ESCHERICHIA COLI BACTERIA TOTAL MAXIMUM DAILY LOAD EVALUATION FOR PIPESTONE CREEK LOCATED IN MOODY AND MINNEHAHA COUNTIES, SOUTH DAKOTA.

South Dakota Department of Environment and Natural Resources

November, 2011

Figure 2: Pipestone Creek Watershed within South Dakota and listed segment indicated by red stream length, T28 indicated by a green circle in the upper watershed and T29 is indicated by a green circle in the lower watershed.

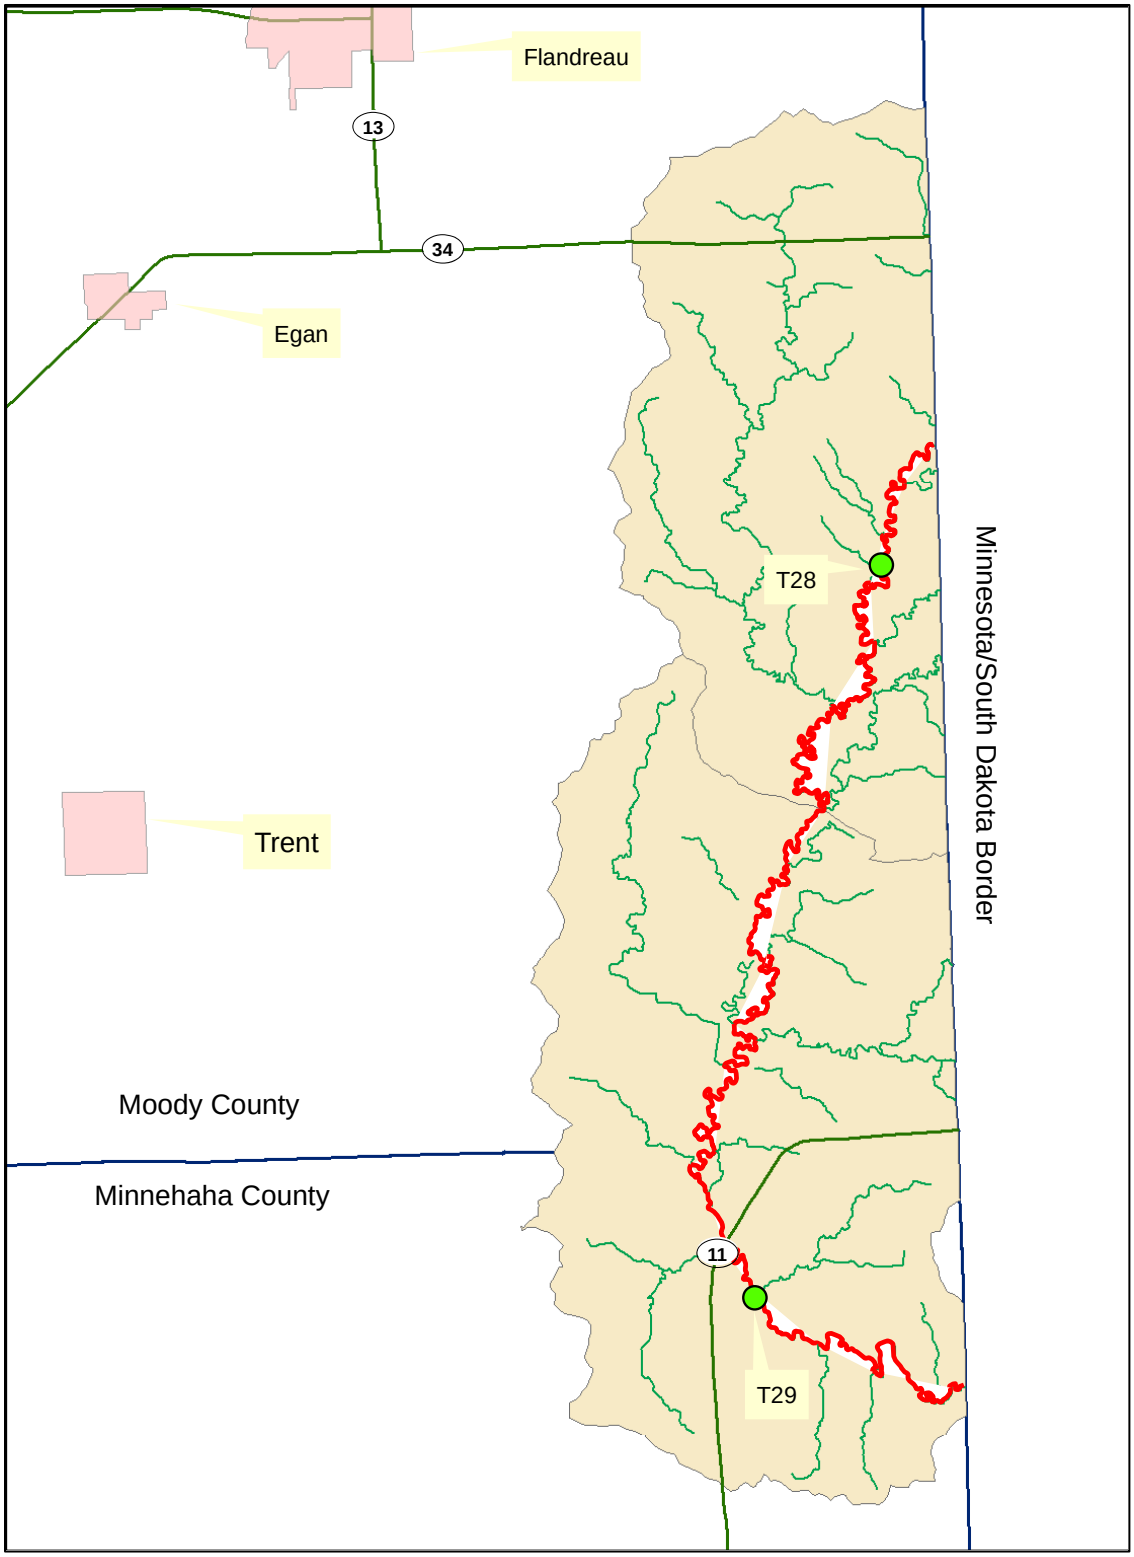
3. *Figure 2 on page 6 could be improved by the following additions:*

a. *Identify the boundary of South Dakota and Minnesota on the figure.*
    b. *Identify sampling points T28 and T29 on the figure.*
    c. *Identify the boundary of Moody and Minnehaha Counties on the figure.*

SD DENR Response: Appropriate labels are included in Figure 2.

Figure 4: Location of sites T28, T29, T30, and USGS gaging station 06482610.

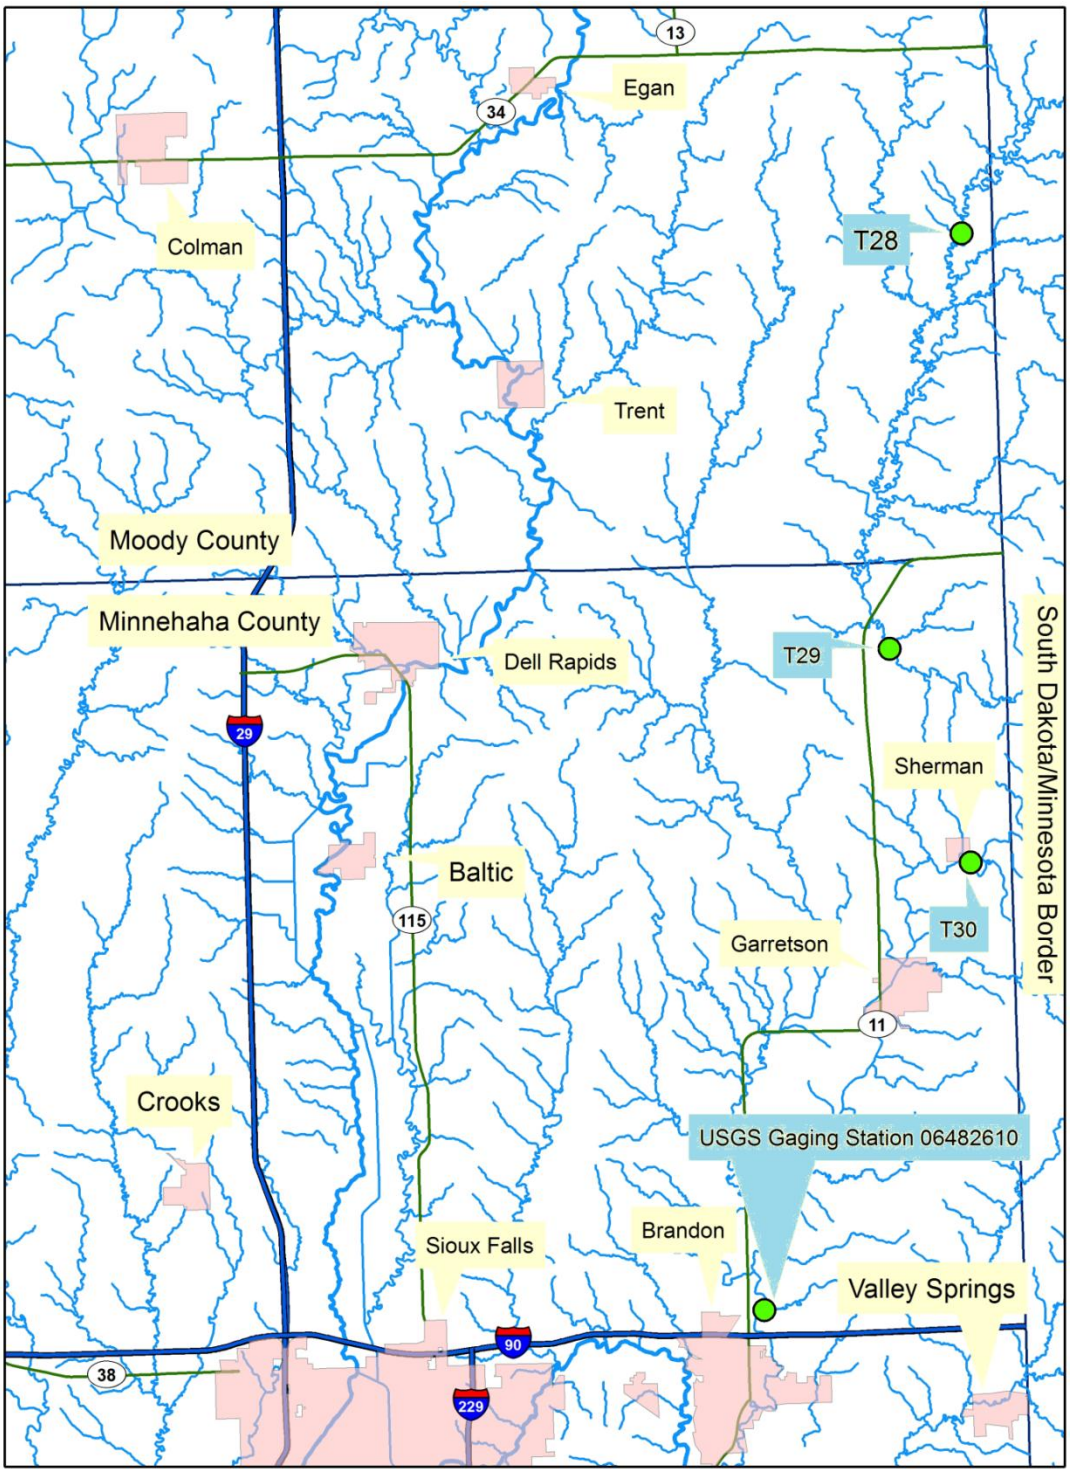
6. *Please indicate on a figure (we suggest Figure 2) the locations of the USGS gaging station 06482610 and stream sampling location T30.*

SD DENR Response: These sites were added to Figure 4 in Section 3.3.

Figure 6: Flow data from T29 dating from 7/6/2000 through 10/31/2001. Flow data exceeded downstream USGS flow data and was not used to estimate loading.

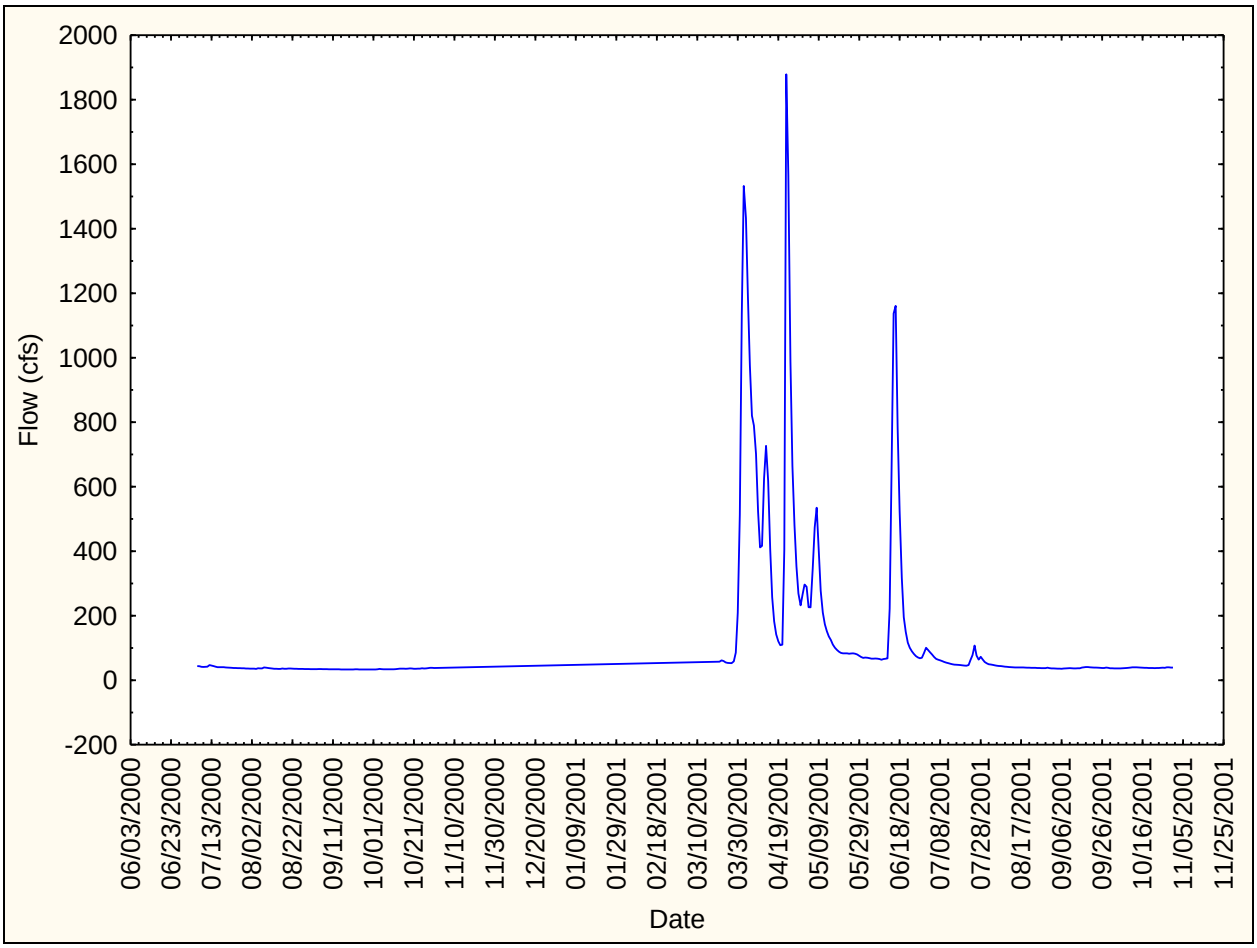
5. *Figure 5 is labeled as the flow record from T30. The text on page 11 indicates that Figure 5 presents the flow record from T29. Please check this and correct as necessary. Flow data from all three locations, T28, T29, and T30 should be presented.*

SD DENR Response: The paragraph states that T28 flow data was used in place of T29 data because it was more reliable, T30 data overlapped with the USGS data and was adjusted to match the USGS flow record. Flow data from T29 is now provided.

Figure 12: Seasonality of flow and E. coli concentrations.

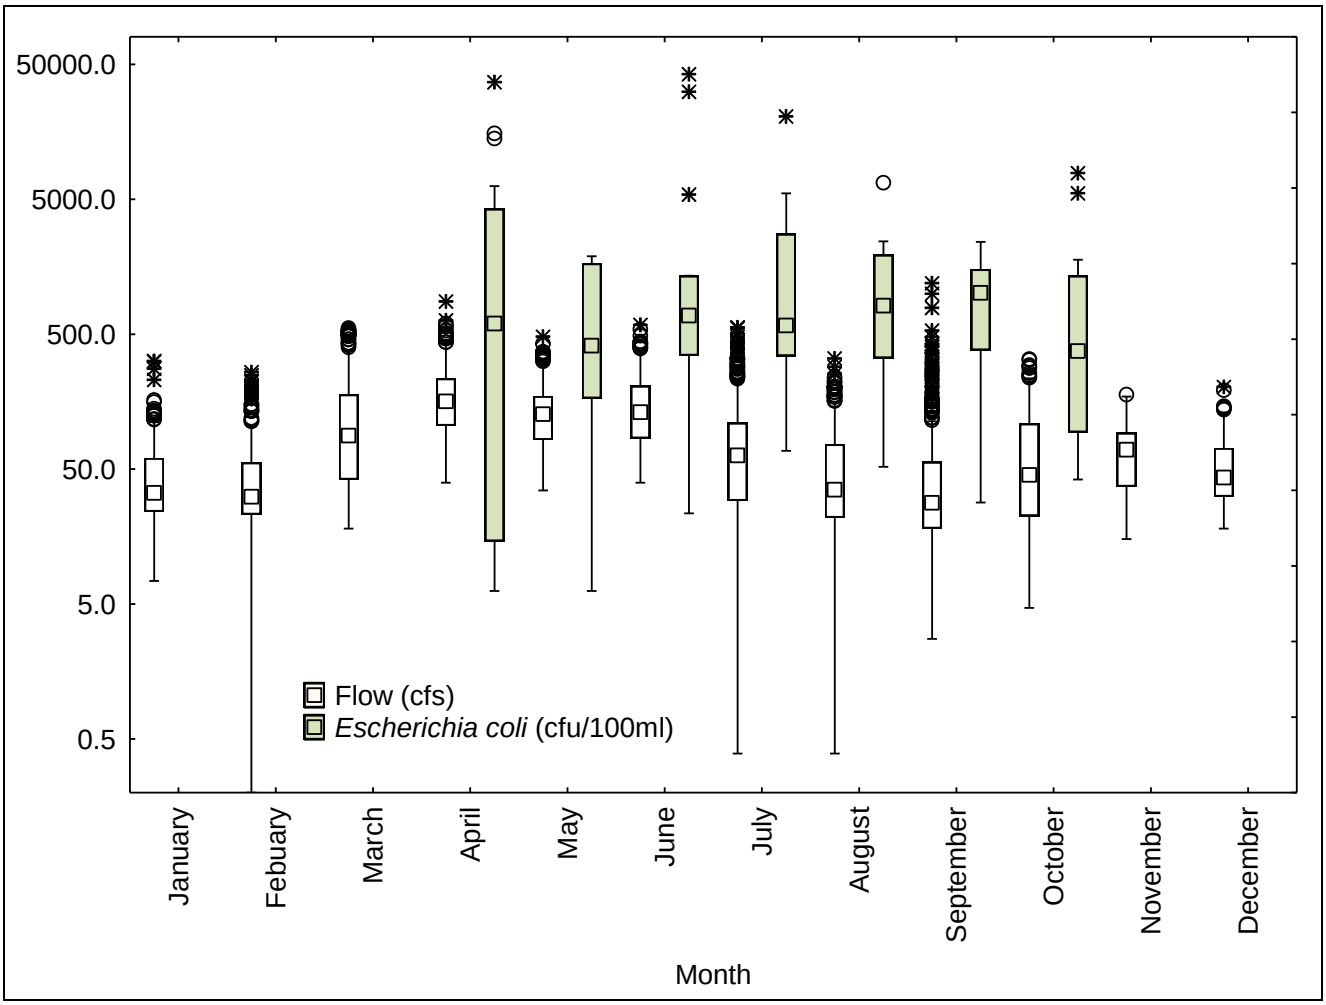
1. *Please add labels and units to Figure 9 to indicate the magnitude of the E. coli concentrations. Also, indicate whether the data in Figure 9 are a combination of data from T28 and T29 or are something else.*

SD DENR Response: The data are a combination of T28 and T29 and the figure title was changed to indicate this. The units for *E. coli* were added to the figure.
